GY-HM200/GY-HM170 INSTRUCTIONS Notification of Changes

This is a notification on the addition of new features, feature modifications and onscreen display changes. Please read this together with the "INSTRUCTIONS".

"98%" added to [Top] and [Bottom] of menu item [Zebra]

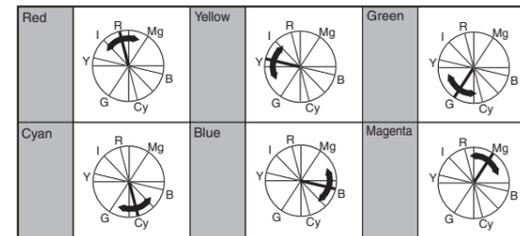
"98%" is added to the setting values for specifying the upper and lower limits of the luminance level in [LCD/VF] → [Shooting Assist] → [Zebra]/[Top] and [Bottom].

This convenient setting is to keep the video level with 100% during the video production for playback, screening and broadcasting on nonlinear devices and PC.

[Top] [Setting Values: 5% to ● 80% to 95%, 98%, 100%, Over]
[Bottom] [Setting Values: 0% to ● 70% to 95%, 98%, 100%]

[Adjust] added to menu item [Color Matrix]

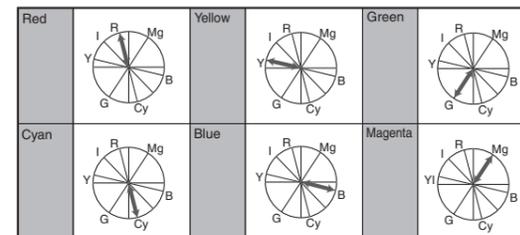
[Adjust] is added to [Camera Process] → [Color Matrix].

- Adjust the "Saturation". [Setting range: -10 to +10] (roughly ± 10%)
 - Press the cross-shaped button (▶) to move the cursor to "Saturation".
 - Each of the colors changes in the direction indicated by the arrow on the vector scope.
 - Pressing the cross-shaped button (▲) moves the color outward from the center of the circle on the vector scope.
 - Pressing the cross-shaped button (▼) moves the color toward to the center of the circle on the vector scope.
